Ipsen Biopharm, Ash Road, Model Review

Rev No 1.0

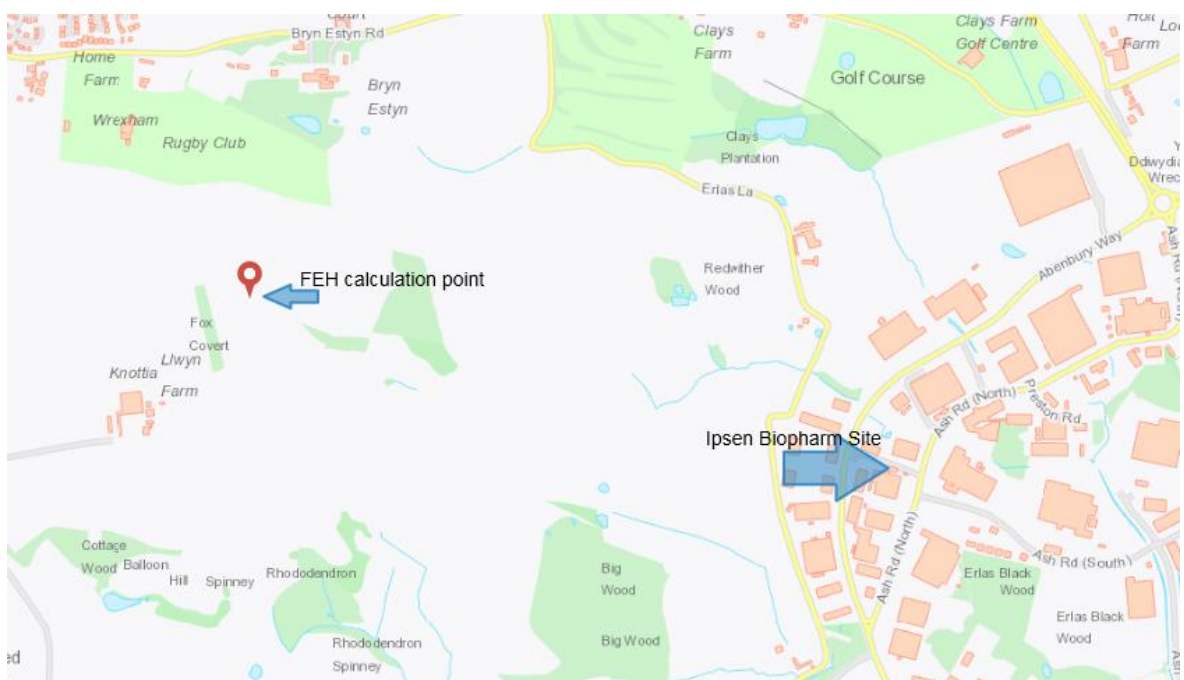
The catchment is too small for the FEH Webservice DTM to pick up. As such, a nearby donor site has been used to derive peak flow estimates, with flows scaled by area to make them applicable to the subject site. This approach is acceptable, however the way this approach is presented in the calculation record is confusing and warrants clarification. For example:

- Where is the donor site located?
- Section 2. The grid reference plots in the middle of a field – please check.

- Section 2. Is this site (RC6472) and associated catchment descriptors presented in the tables related to the actual subject site catchment, or the donor catchment?
- If Section 2 details do relate to the donor site, what is the catchment area of the subject site?
- Table 3.3. Gives QMED estimate of 0.08m³/s. Table 3.6 gives QMED of 0.07m³/s. Table 5.1 gives QMED of 0.08m³/s. Table 5.5 gives QMED of 0.07m³/s. I assume these two values represent QMED for the donor site (0.08m³/s) and QMED scaled by catchment area to the subject site (0.07m³/s) ? Or are they typos? Please can this be explained clearly.
